CITY OF AUSTIN – DEVELOPMENT SERVICES DEPARTMENT
SITE PLAN APPLICATION – MASTER COMMENT REPORT

CASE NUMBER: SPC-2009-0362C(R2)
REVISION #: 3
CASE MANAGER: Clarissa E. Davis

PROJECT NAME: Waller Creek Tunnel Project- Waller Beach Improvements SPR #2
LOCATION: 74 TRINITY ST

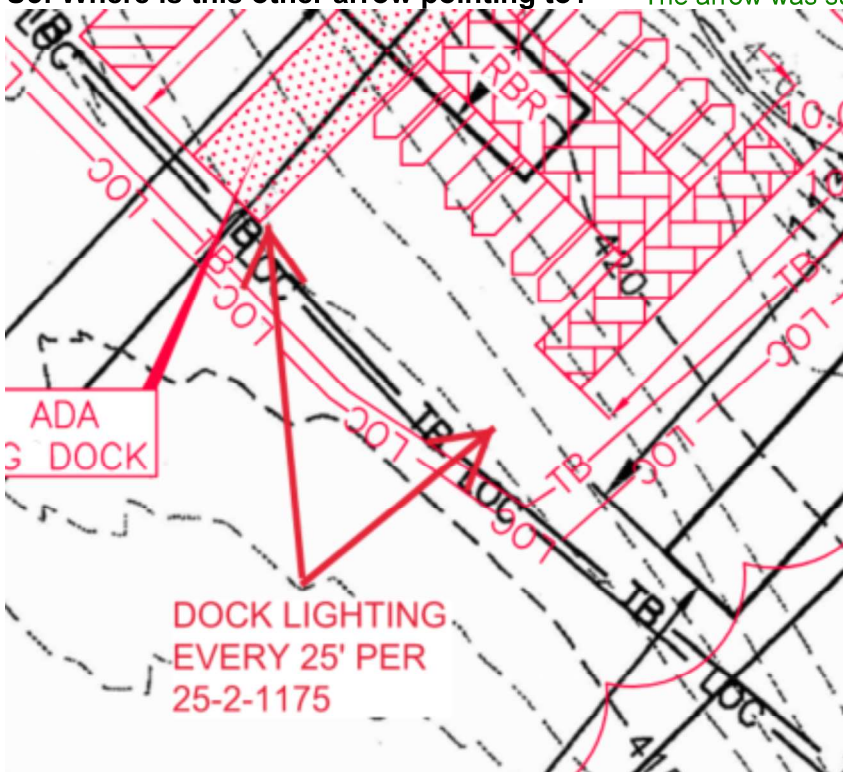
WB3. The blue polygon below delimits existing non-compliant construction that is not on the approved site plan. This should be shown to be demolished.

WB4. The red polygon circled in blue appears to be extraneous and should be removed from any sheets showing the final condition.

WB3. Cleared. Sorry for the confusion on this. I was mis-remembering conversations on non-compliance at this location and also the relevant bit of code. The issue with the second access point in terms of compliance was that it had not been permitted through a site plan, not that it would not be allowed without a variance. Code prohibits second access points only for single-family residential lots, so that rule does not apply in this case. My current understanding is that a variance is not needed for the second access point. Thank you

U3. Cleared. See WB3 comment above. Thank you
